8747 Brook Road McLean, Virginia

RPA ENCROACHMENT EXCEPTION #3276-WRPA-003-1 & WATER QUALITY IMPACT ASSESSMENT #3276-WQ-004-4
SECTION 118-6-9, GENERAL RESOURCE PROTECTION AREA ENCROACHMENT REQUEST

APPLICANT REPRESENTED BY TNT ENVIRONMENTAL, INC.

118-6-6.a – Is the Minimum Necessary to Afford Relief

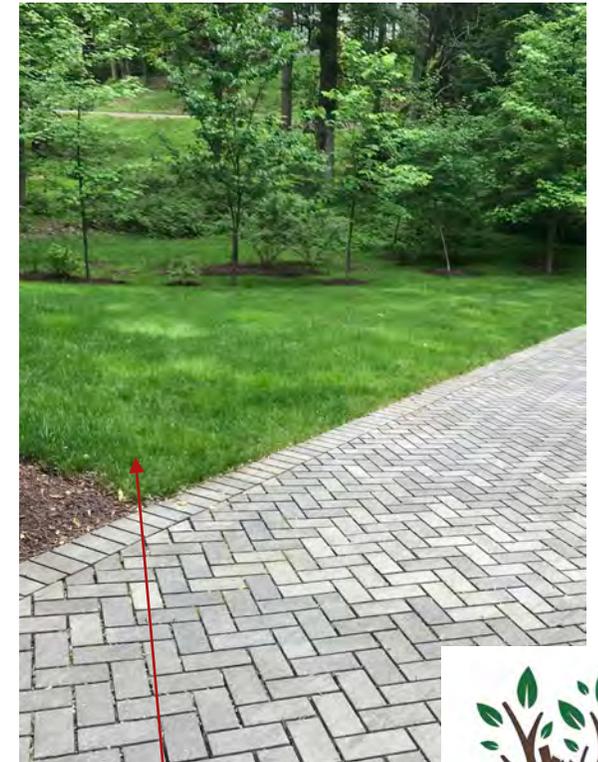
- Staff Comment: The currently requested driveway turn-around was not included in the original exception application and is therefore not the minimum necessary to afford relief.
 - The need for the turn around was not envisioned in 2012
 - USPS delivery across USA has increased from 3.5 billion in 2012 to 7.3 billion (207% growth) in 2020 (statistics pre-Covid pandemic)*
 - Amazon 2019 annual delivery was 1.9 billion packages compared to 750 million in 2018 (255% growth)**
 - FedEx Ground between the fiscal years of 2016 and 2021 has grown from 1.93 to 3.13 billion (162% growth)***
 - As is, delivery trucks are required to reverse 165-feet down the driveway and to back up on to Brook Road
 - Brook Road – ~1,250 vehicles per day (VDOT Daily traffic Estimate for 2020)

- There was also to be a rain garden/infiltration trench between Brook Road and the trench basins that can handle runoff from Brook Road. See The Final Meeting Minutes October 3, 2012, Attachment C1. The need for the turn around was not envisioned in 2012.
 - Per approved Water Quality Waiver Conditions Analysis, alternatively, the applicant could provide a “Vegetated buffer area containing at least 10,000...[to] meet the density requirements per CBPO 118-3-3(f).
 - The proposed 330 square feet (sq. ft.) of RPA disturbance occurs within the footprint of the 2012 exemption request for RPA disturbance;

Approx. location of proposed turn around

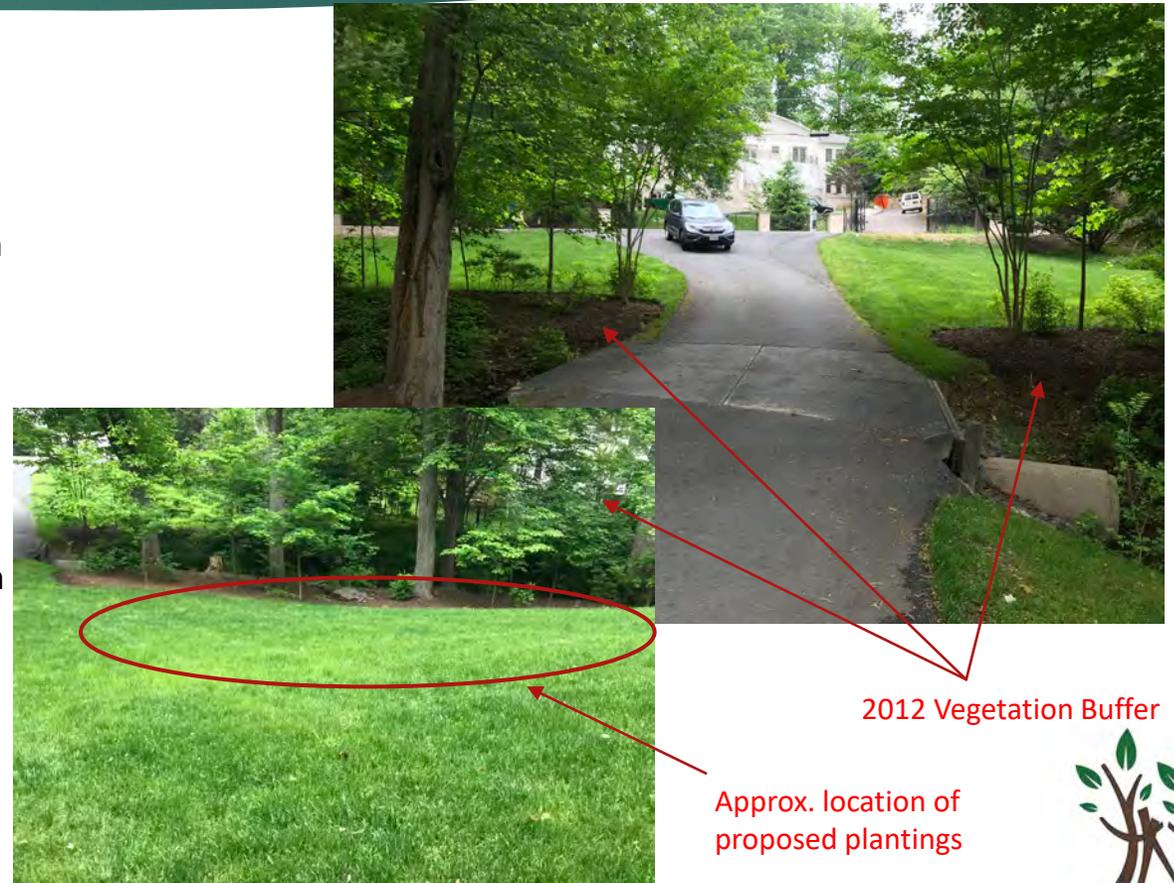
- It is staff's opinion that the exception for a driveway itself would not confer a special privilege. However, if approved, the "serial exception" nature of this exception request is itself a special privilege.
 - The applicant is not requesting a "serial exception". This is only the second request for exemption on this property, the first occurring over 9 years prior.
 - Serial implies the applicant is requesting exemptions in instalments to avoid public hearing.
 - 2012 ERC approved exception to allow for the construction of a dwelling, guesthouse, and pervious paved courtyard
 - 2020 exception request to ERC for installation 3-point turn around extension of the driveway to meet unforeseen needs concerning safety of exiting vehicles along Brook Road.

118-6-6.d – Is Not “Self-created” Or “Self-imposed”

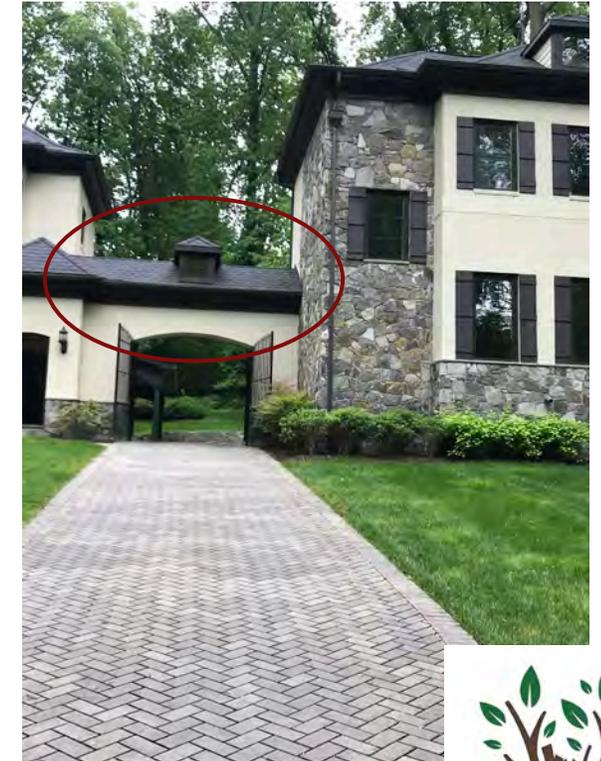
- This request for further encroachment in the RPA beyond and in addition to the previously approved encroachment, and this desire to use more of the RPA is self-created as evidenced by the fact that it was not included in the original application as the minimum encroachment needed.

- The Virginia Supreme Court makes clear that the language “self-created” or “self-imposed” condition refers to violating the zoning ordinance and then asking for a variance to redress the violation, *Spence v. Board of Zoning Appeals for the City of Virginia Beach*, 255 Va. 116, 496 S.E. 2d 61 (1998).

- The lack of a turn-around in the 2012 application is not evidence of a violation. The request for this exemption (no violation involved) would itself refute such allegation.

- The request is to alleviate hazardous back-up conditions for delivery vehicles and others on to Brook Road which has been designed and constructed by others.
